June 1, 2016
Project No. 1948F

**RE: Response to Amended Order of Conditions Review Comments
DEP File No. SE049-0693
200 Theodore Rice Boulevard**

Field Engineering Co., Inc. has received the Request for Amended Order of Conditions review comment letter dated May 27, 2016 prepared by Nitsch Engineering and has prepared the following response narrative and supporting documentation for consideration by the Commission.

| STRUCTURE: | A | B | C | D | E | F | G | H | I |

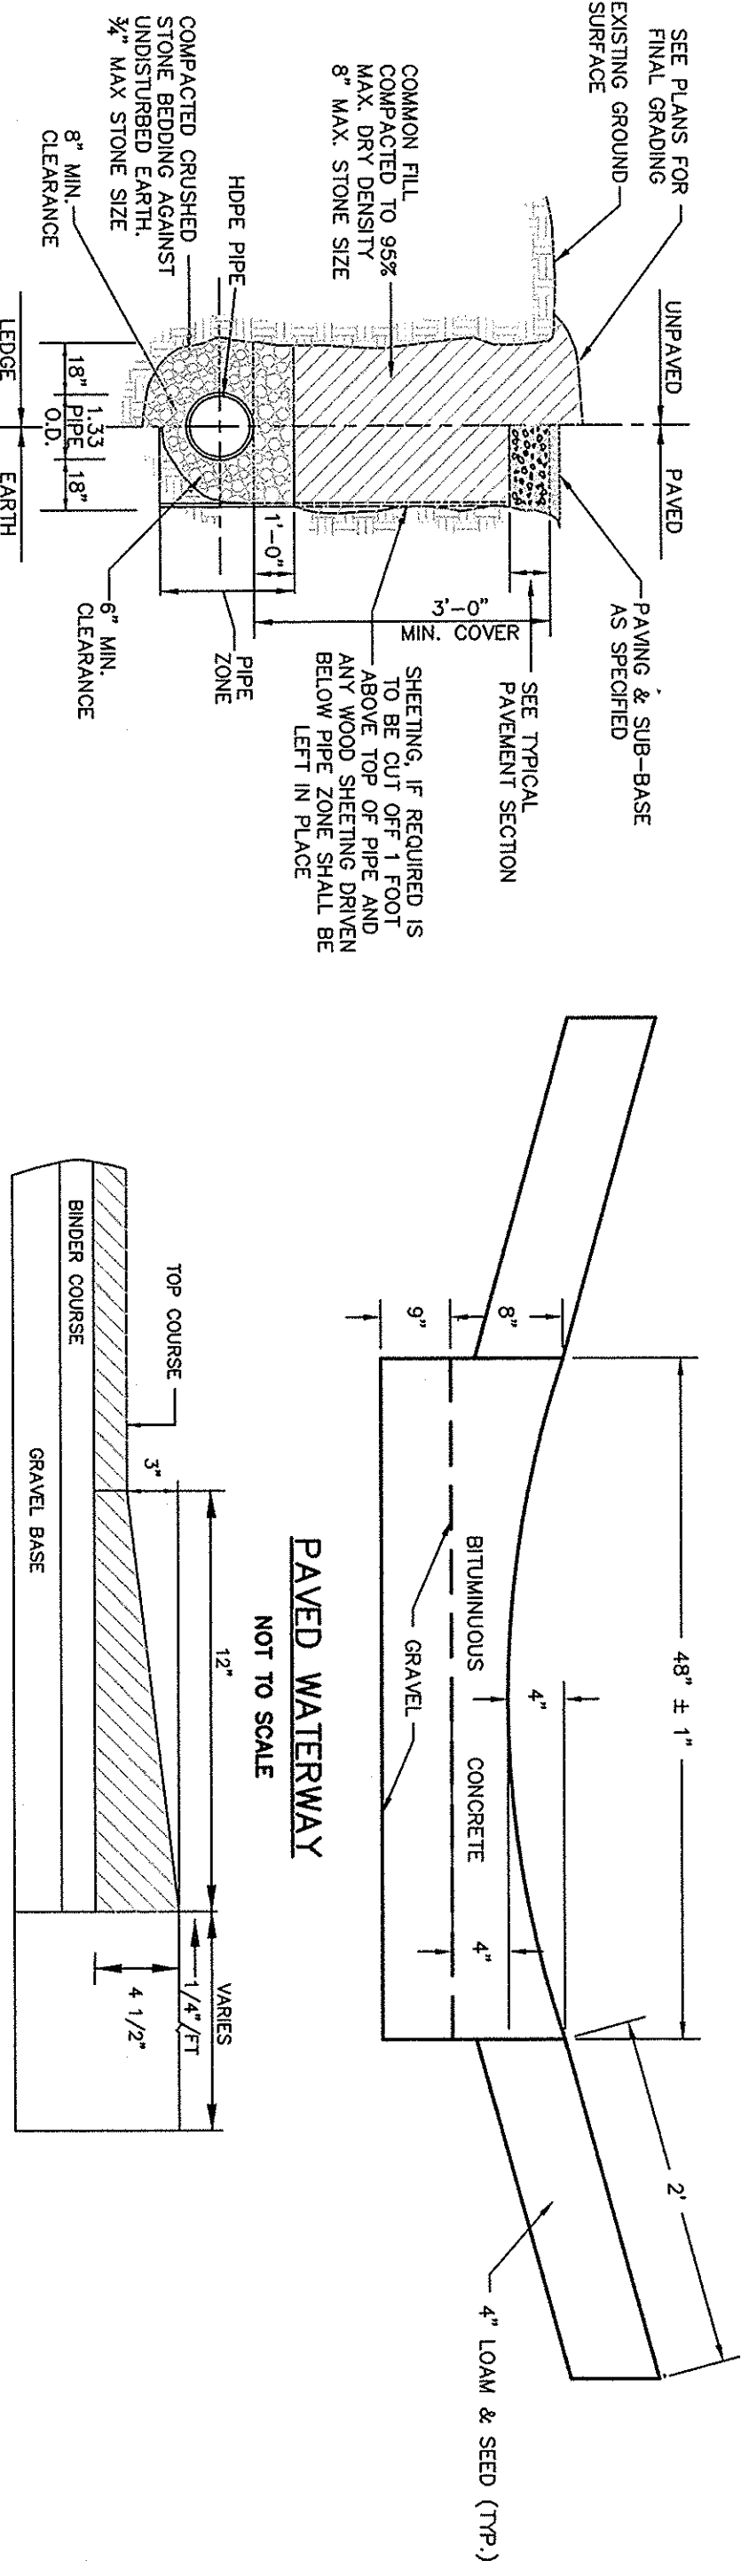
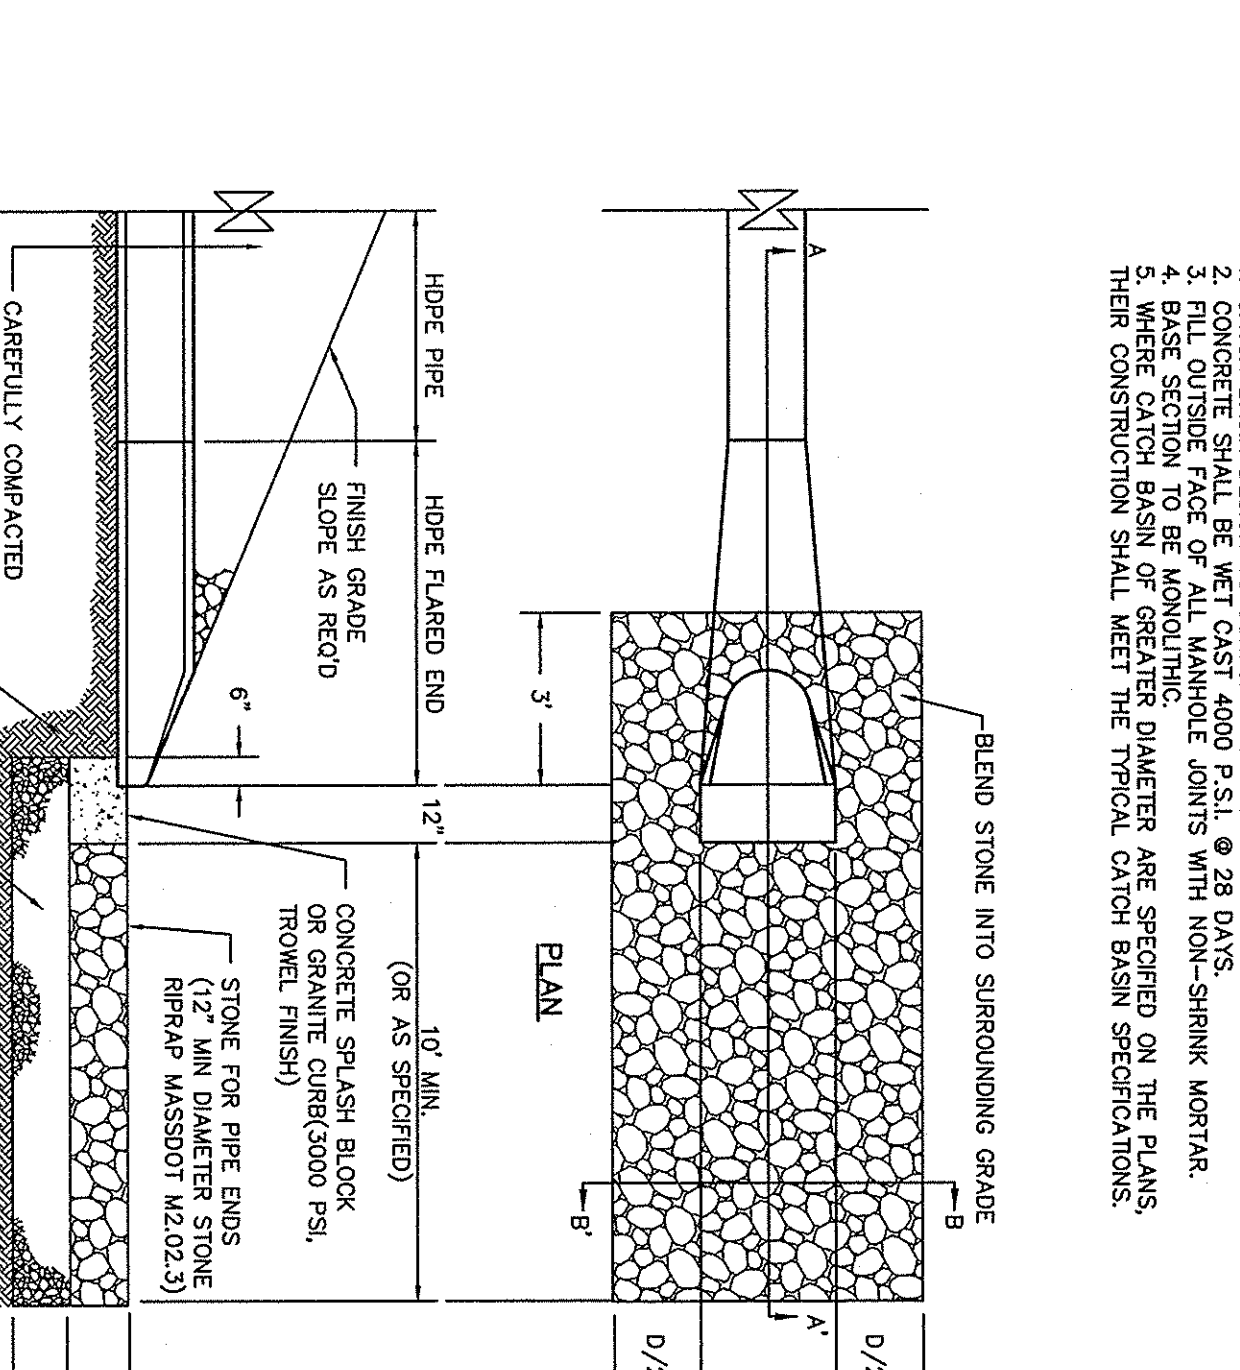
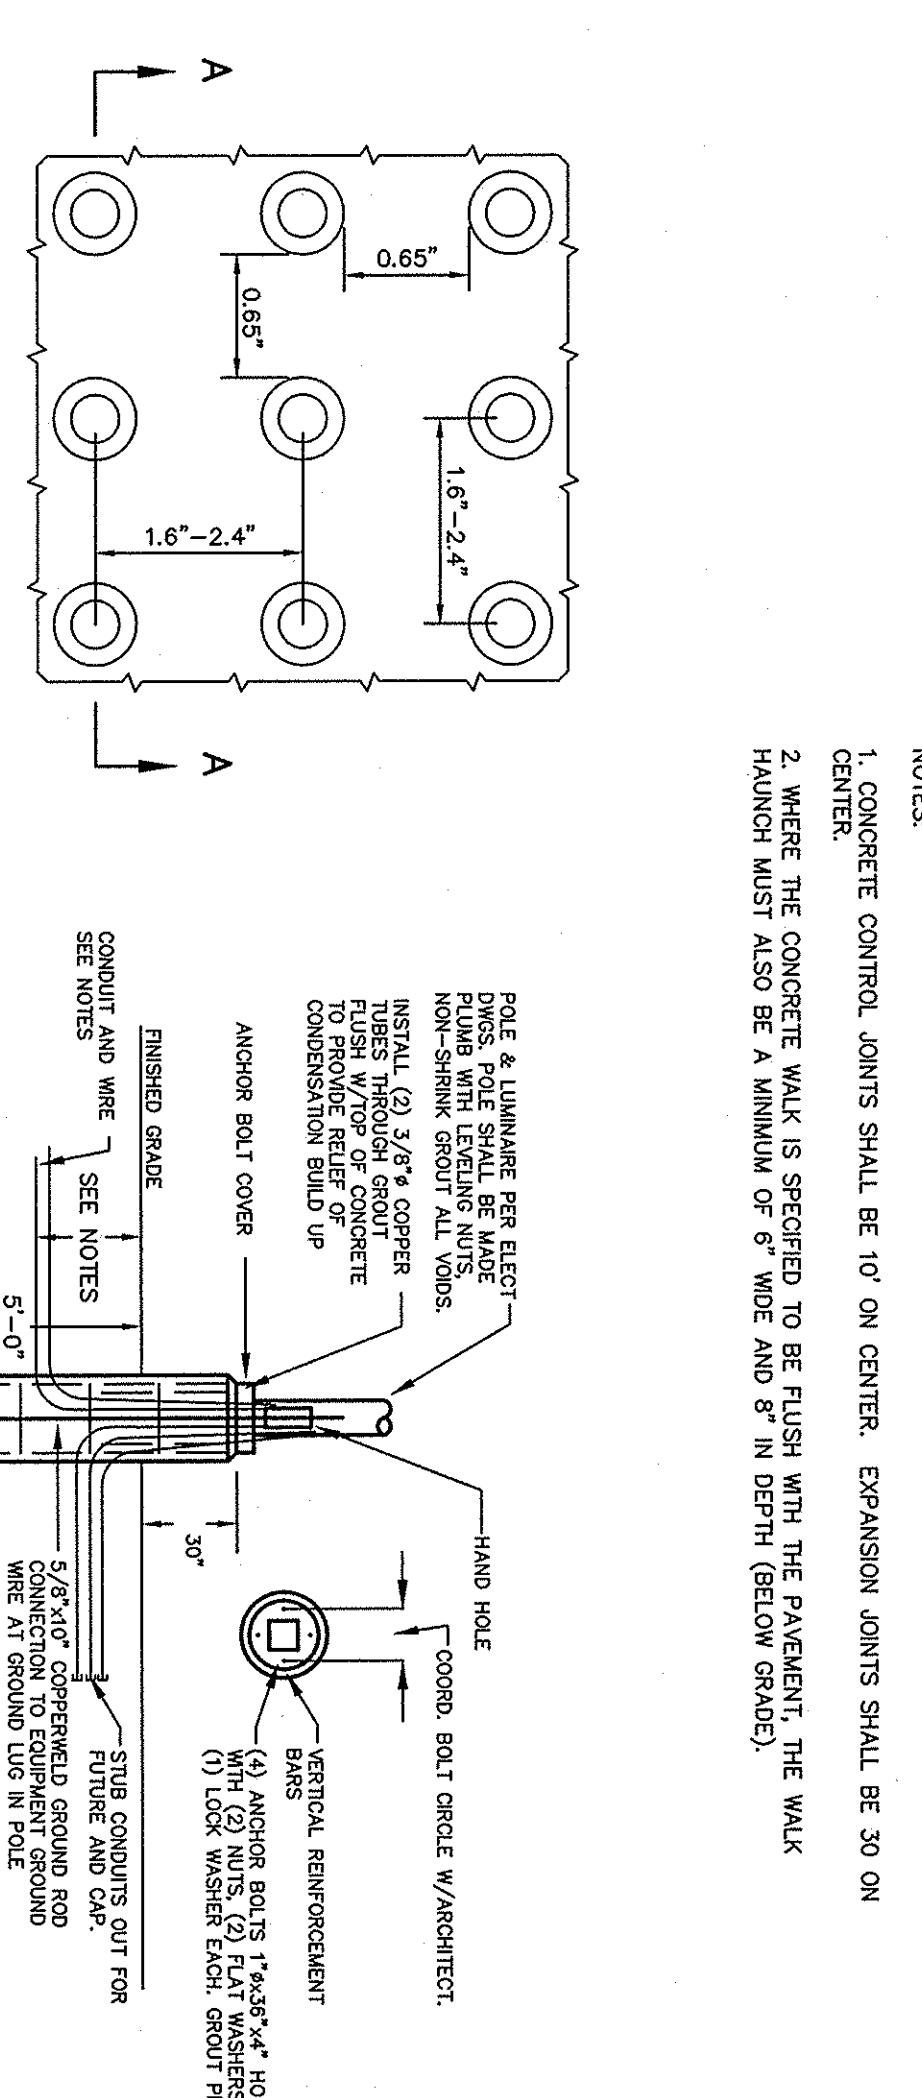
9. The request for an Amended Order of Conditions included one sheet only. There were not any revised details submitted with the revised plans. Comparing the approved calculations with the calculations submitted with the Amended Order of Conditions request indicates that there have been some minor modifications to the outlet control structures from the detention basins. These details should be revised for consistency with the calculations to ensure they are constructed correctly.

RESPONSE: A Revised Detail Sheet showing updated information for the outlet control structures has been prepared and is attached to this Letter.
